**REQUEST FOR TENDER
FOR
Lighting Retrofit Tender
St. Clair Catholic District School Board
Multiple School**

RFT #: CP1616(Rev1)

ADDENDUM #1
QUESTIONS & ANSWERS

Issued for Tender	School No.	Monsignor Uyen Catholic School	Lighting Retrofit Plan		Dwg No. 618-1
	618		Retrofits and Fixture Deletions		
	255 Lark St Chatham, ON N7L 1G9		Date: 04.15.2016	Scale: NTS

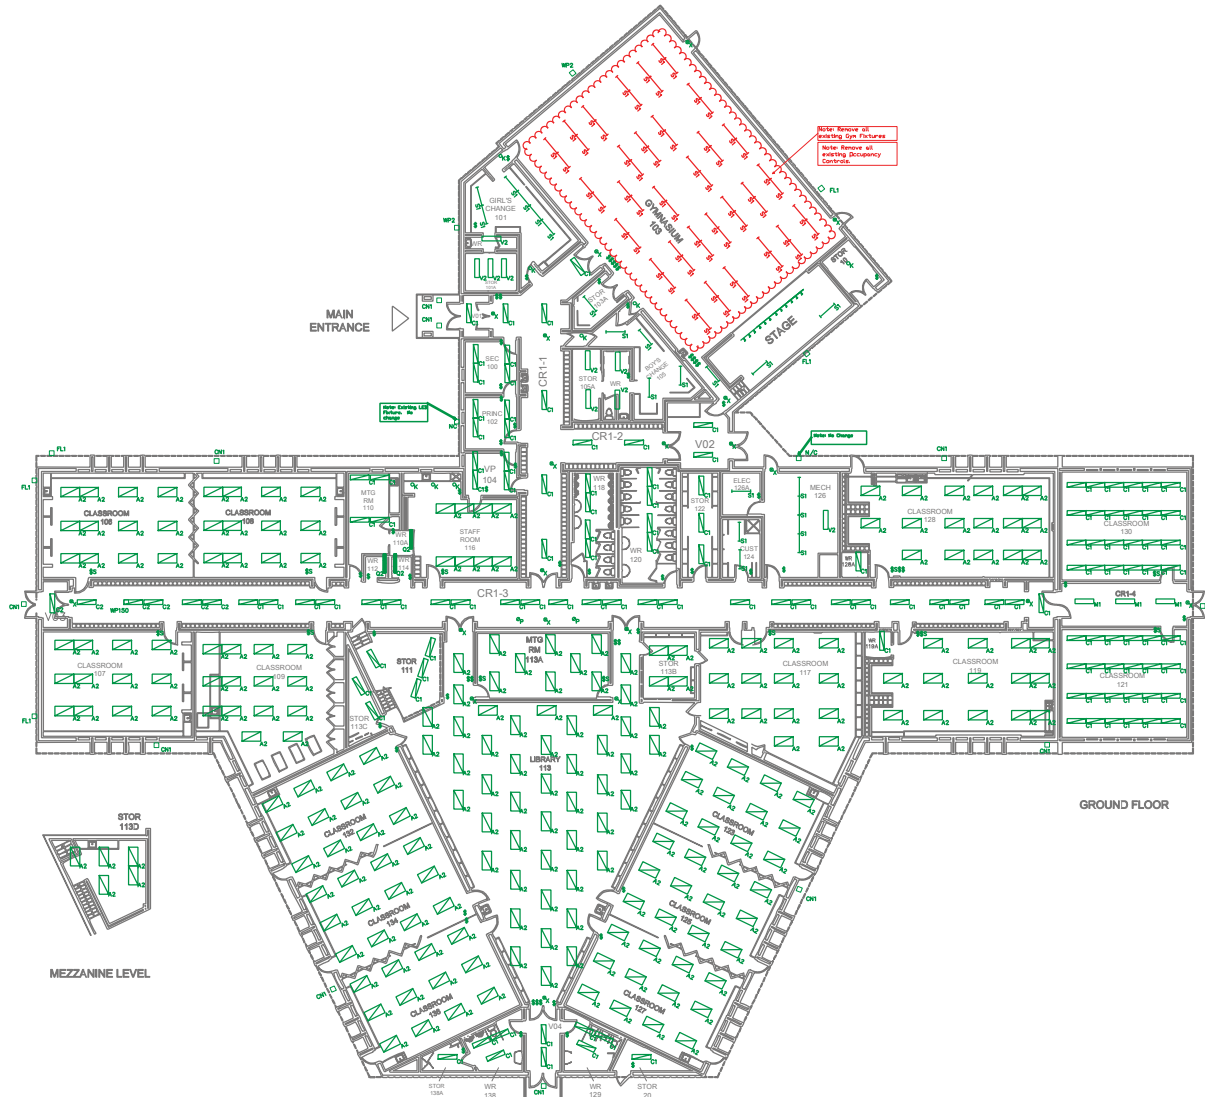
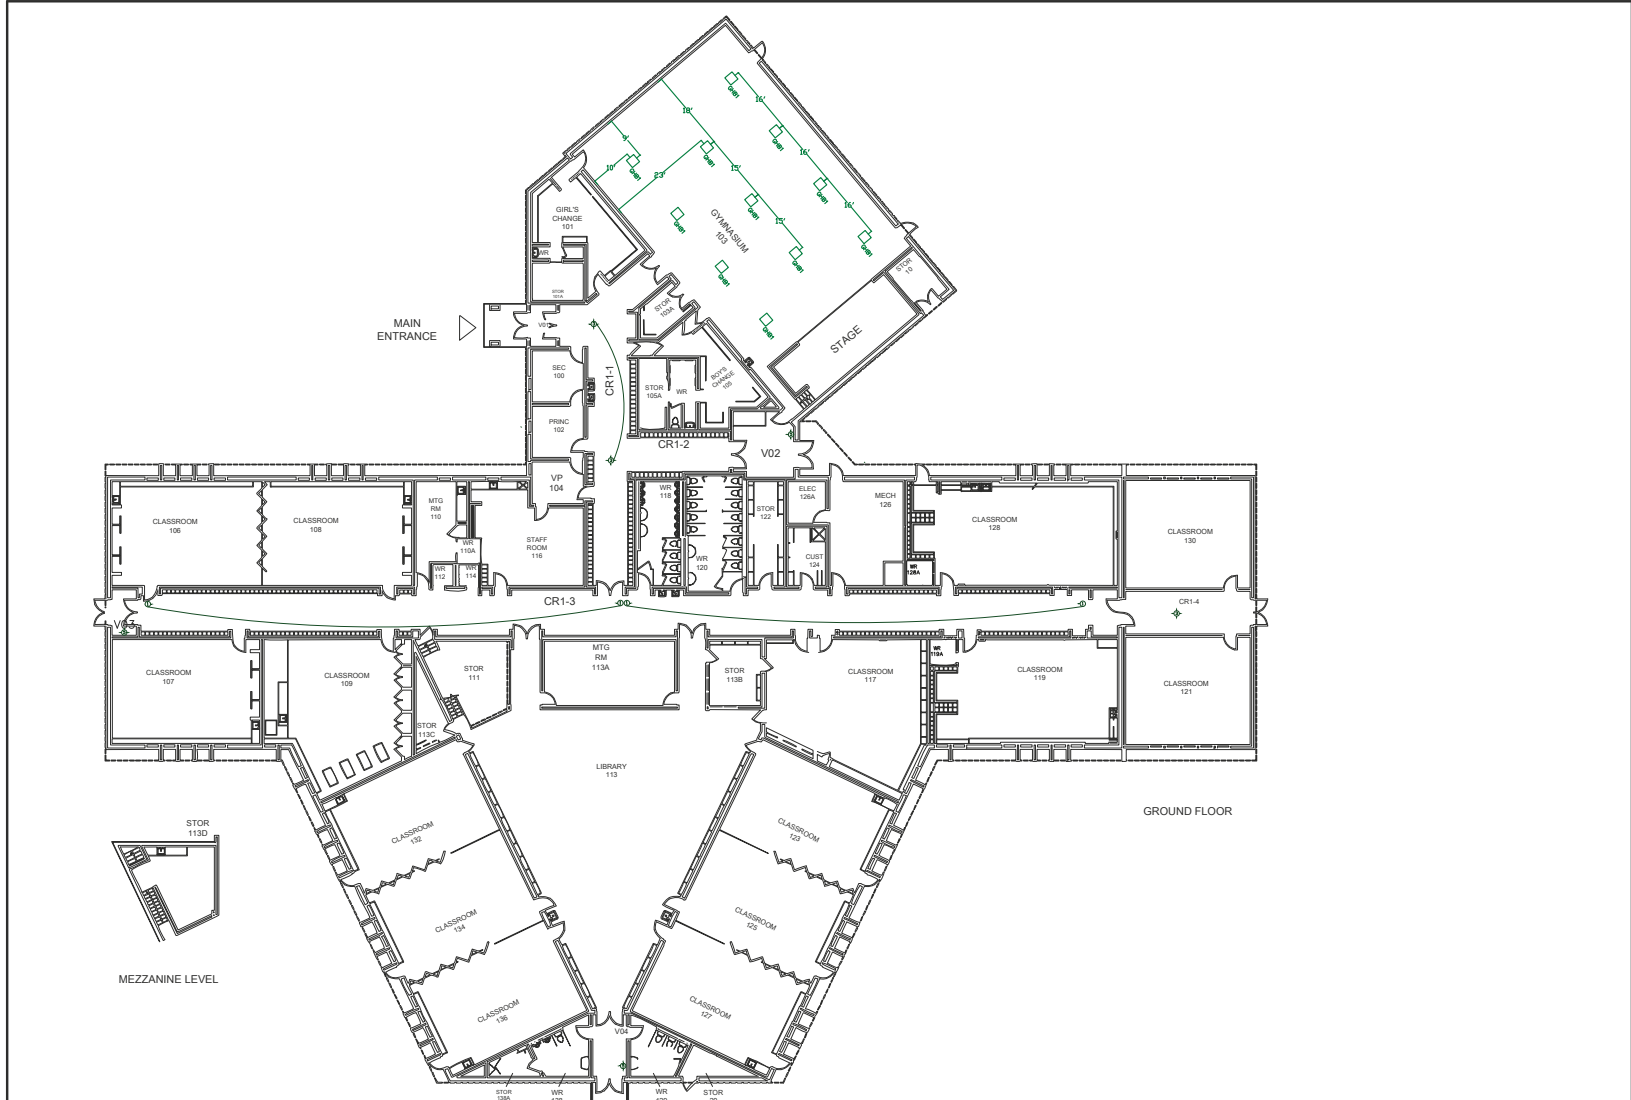
- Q2. Is it necessary to be a union company to quote the project?
- A2. No – Union affiliation is not a requirement.**
- Q3. Please clarify the quantity of Occupancy sensor for the site 618 Monsignor Uyen

- A3. See revised document “Tender # CP1616 Lighting Retrofit St. Clair Catholic District School Board(Rev1)”**
- Q4. Do Gym fixtures come with wire guards?

Issued for Tender	School No.	Sacred Heart Catholic School	Lighting Retrofit Plan		Dwg No. 622-1
	622		Retrofits and Fixture Deletions		
	434 John Street Port Lambton, ON, N0P 2B0		Date: 05.13.2016	Scale: NTS

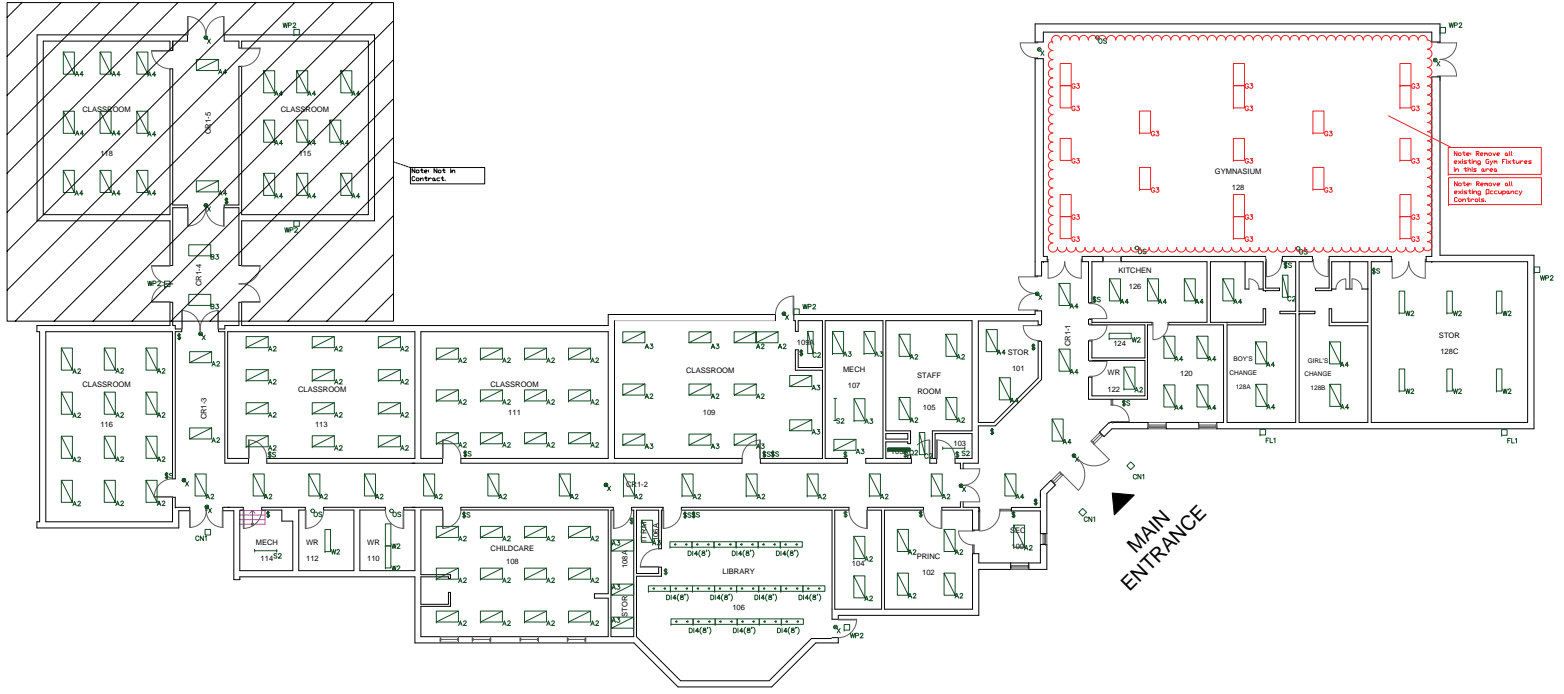
- A8. The difference is in mounting hardware (Trunnion, Slipfitter). Refer to spec document for details.**
- Q9. DI4(8') to DI4(8') doesn't exist in the drawing of site 622, please can you specify its location?

- A9. Drawing corrected in “Tender # CP1616 Lighting Retrofit St. Clair Catholic District School Board(Rev1)”**
- Q10. Will we be allowed to use school cafeteria? Will we be required to return the class rooms to as found conditions every night or can they be left until completion?
